# Report to the Advisory Committee of Experts for Nuclear Pressure Equipment

**CODEP-DEP-2015-037971**

**Session of 30 September 2015**

**Analysis of the procedure proposed by AREVA to prove  
adequate toughness of the domes of the Flamanville 3  
EPR reactor pressure vessel (RPV) lower head and  
closure head**

Figure 10: US inspection using 45° shear waves on the domes and direction of sensing

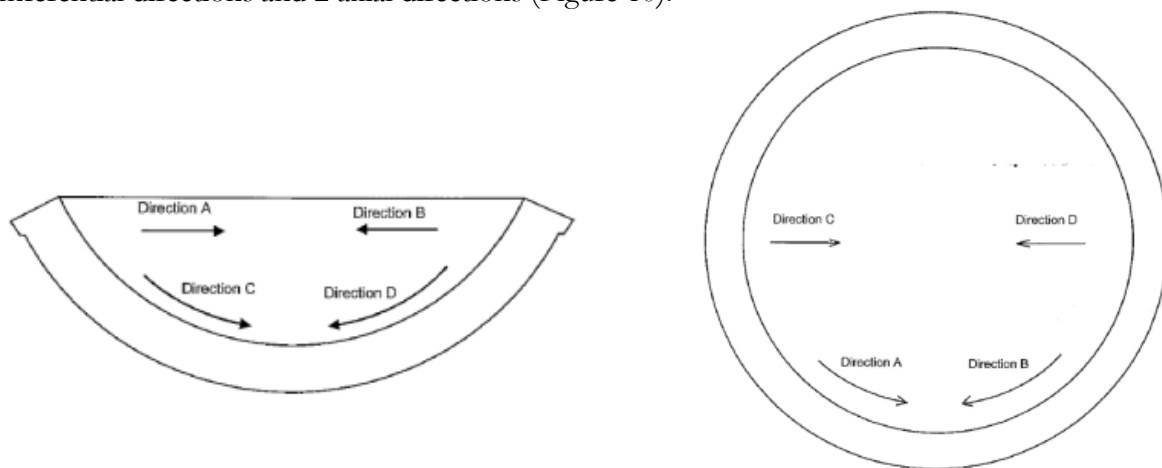
The performance values indicated by AREVA for flaws perpendicular to the outer skin are on the whole consistent with current know-how. They are backed up by the simulations carried out for assessment of this file (see Annexe 3). Rough or smooth 10 × 20 mm flaws thus remain detectable when surface-breaking or with a small ligament separating them from the surface, including when there is a very slight misorientation as mentioned for the UK EPR study concerning planar type 2 or 3 flaws (see Table 10). The checks cannot however guarantee the detection of “rough” and “very smooth” flaws, in particular

when they are far from the outer skin and mis-oriented. “Very smooth” flaws do not however correspond to realistic flaws for the material in question.

Figure 14: Positions of the 800 x 400 mm pieces

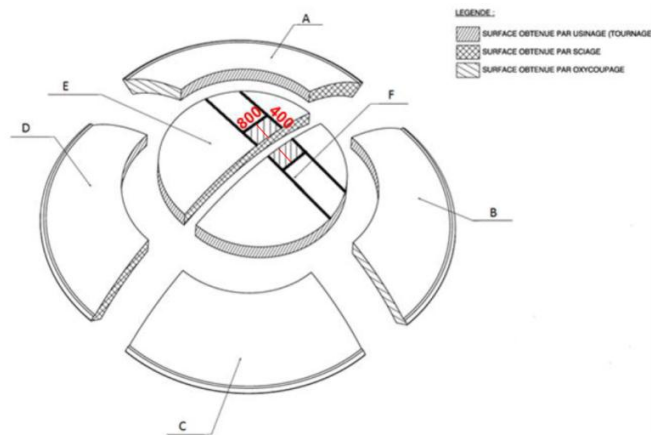
The rapporteur underlines that the limiting situations and loadings were selected assuming that the reduction in toughness in the segregation zone would stop at mid-thickness. The rapporteur notes that the test programme now includes tests at 1/2 thickness, which would validate this core hypothesis of the AREVA dossier. The rapporteur however points out that the results presented in Figure 14 show that the segregation zone exceeds 1/2 thickness.

Figure 21: Detailed demonstration approach – Test sequence

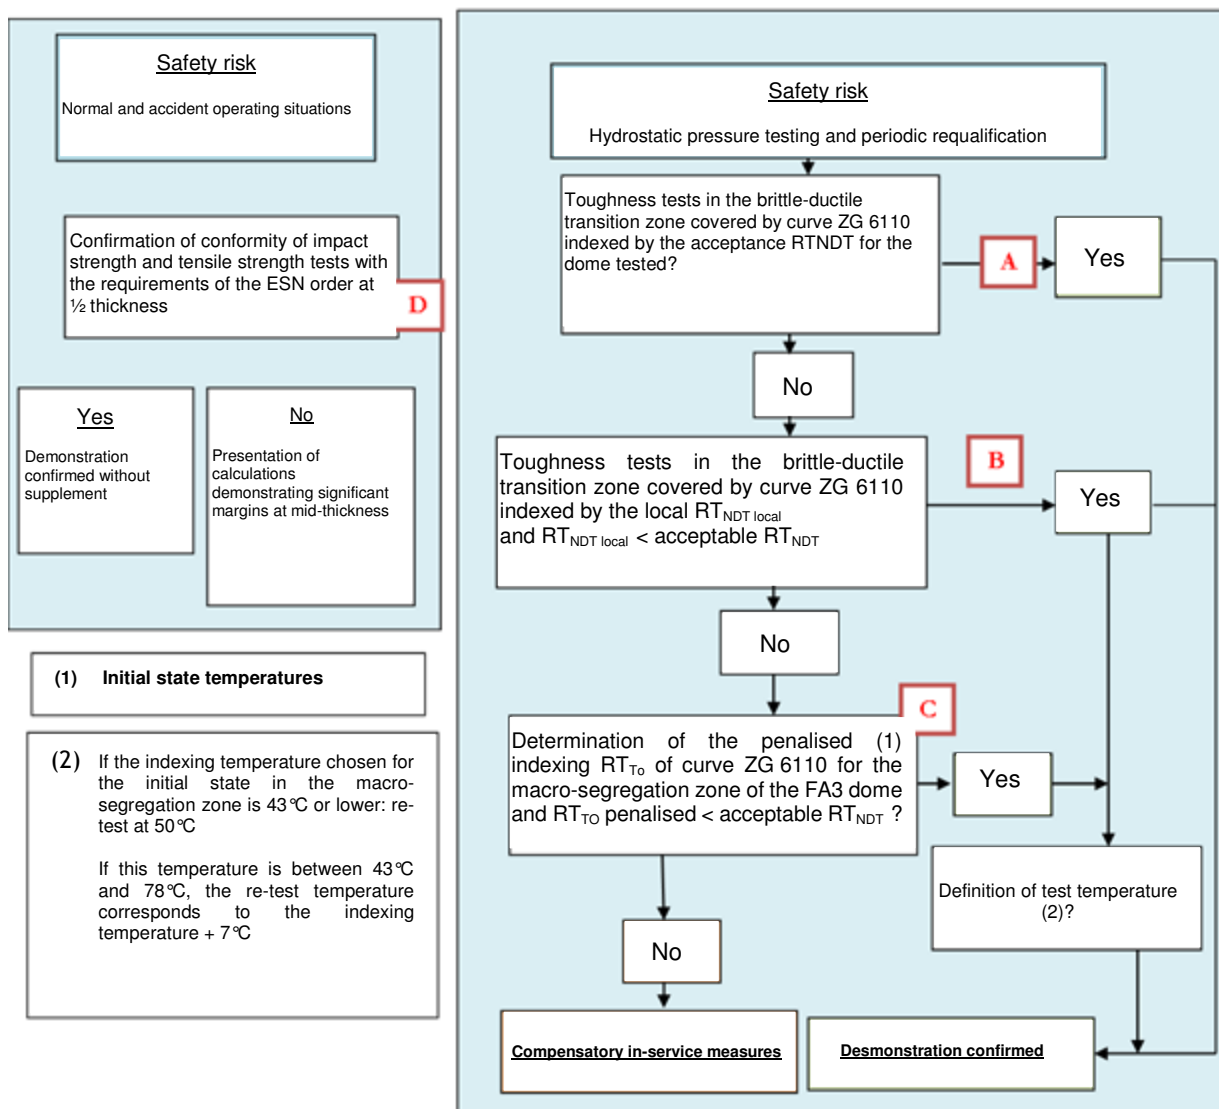
In the case (marked **A** on the flowchart in Figure 21) for which the toughness values measured in the segregation zone are bounded (lower value) by RCC-M curve ZG6110 indexed on the acceptance  $RT_{NDT}$  (test reference **A** on the flowchart), the design file remains applicable.

At the end of the assessment, AREVA also stated that if the mid-thickness bending rupture energy value was not met (marked **D** on the flowchart) the test programme planned at mid-thickness would be able to demonstrate adequate toughness, in the same way as the approach proposed for the hydrostatic pressure tests.

The rapporteur points out that this calls into question the determination of adequate toughness proposed by AREVA (paragraph 4.2) and thus the associated demonstration approach.

Consequently, test **A** is only acceptable if supplemented by a verification of the margins with respect to the fast fracture risk, considering the curve of appendix ZG indexed on the local  $RT_{NDT}$  and not on the acceptance  $RT_{NDT}$ .

Figure 18: Reduction in  $K_{IC}$  depending on the indexing of the curve in appendix ZG 6110.

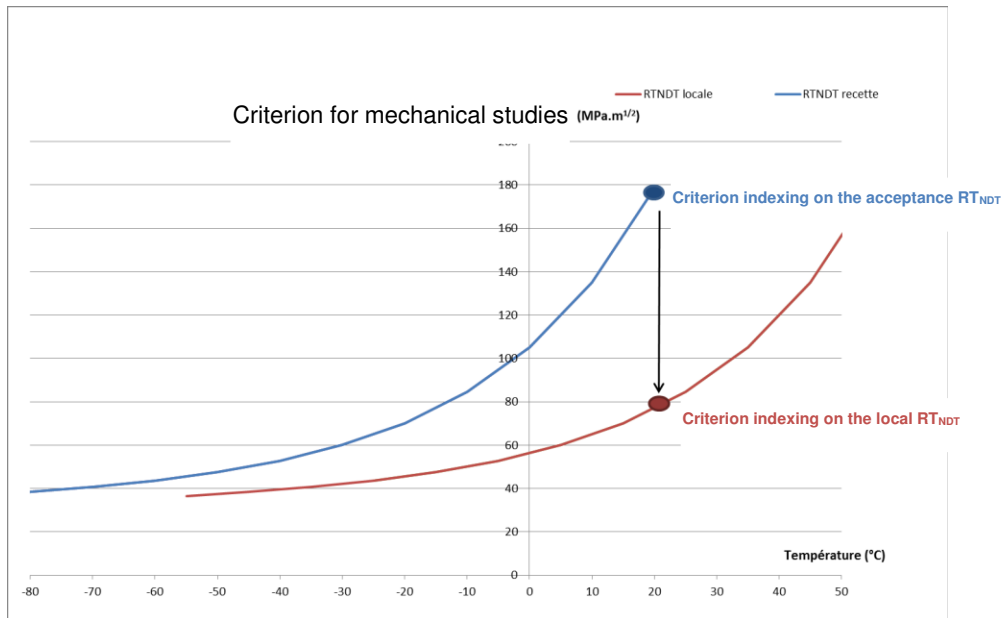
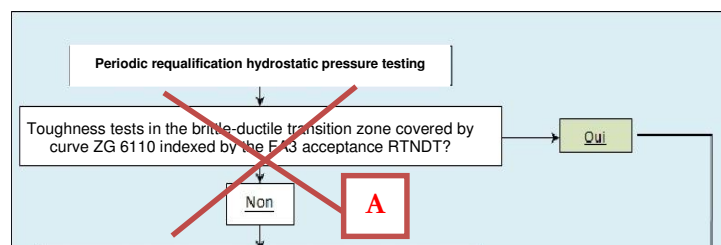
positive macrosegregation zone. However, this does not allow a conservative estimate of the mechanical margins to be made. AREVA estimated that in theory the local  $RT_{NDT}$  of the segregation zone would be higher than the acceptance  $RT_{NDT}$  (offset between 35 and 70°C). The rapporteur points out that the criterion used in the fast fracture analyses (stress intensity factor lower than the toughness given by the indexed ZG curve) associated with the acceptance  $RT_{NDT}$  is less conservative than that which would be associated with the local  $RT_{NDT}$  (Figure 22).

Figure 24: Evaluation by simulation of the detection of rough fracture surface flaws of dimensions 5 x 20 and 10 x 20, perpendicular to the external skin or slightly misoriented

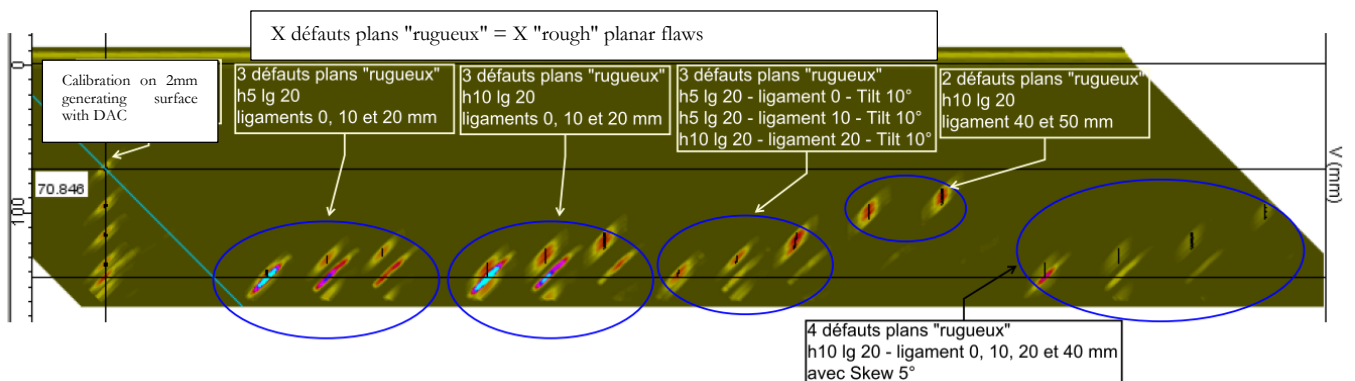
The rough fracture surface flaws very far from the external skin (more than 20 mm) would also be recorded and rejected if they remain perpendicular. The misoriented flaws with a slight skew of 5° appear to be recordable and even rejectable if they are surface breaking or have a small ligament (about 10 mm). These same "skew" flaws would nevertheless not necessarily be recordable and rejected according to the criteria of the RCC-M when they are very far from the external skin (more than 20mm). This is directly visible on the mappings which show that the flaws which are predominantly red in colour are flaws whose amplitude is greater than the 0 dB amplitude of the 2-mm diameter generating surface hole, which leads to the rejection of the flaws.

The misoriented flaws with a slight skew of 5° appear to be recordable and even rejectable when surface breaking or with a small ligament (about 10 mm). These same flaws with a very slight skew are more difficult to record than rough flaws when the ligament exceeds 10 mm.

Figure 25: Evaluation by simulation of the detection of perfectly smooth fracture surface flaws of dimensions 5 x 20 and 10 x 20, perpendicular to the external skin or slightly misoriented

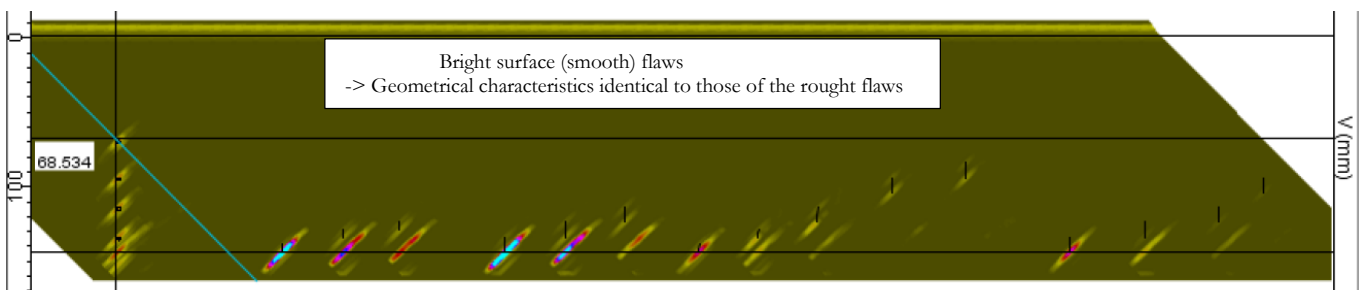
According to the provisions of the RCC-M code, planar flaws of 5 and 10 mm height with very smooth fracture surfaces are also all recorded and are rejected if they are surface breaking flaws or at a distance of 20 mm with respect to the external surface, in the cases retained for the simulations when they are perpendicular or slightly misoriented in tilt. These same perpendicular flaws would be recorded but not necessarily rejected if they are very far from the external skin (more than 20 mm).
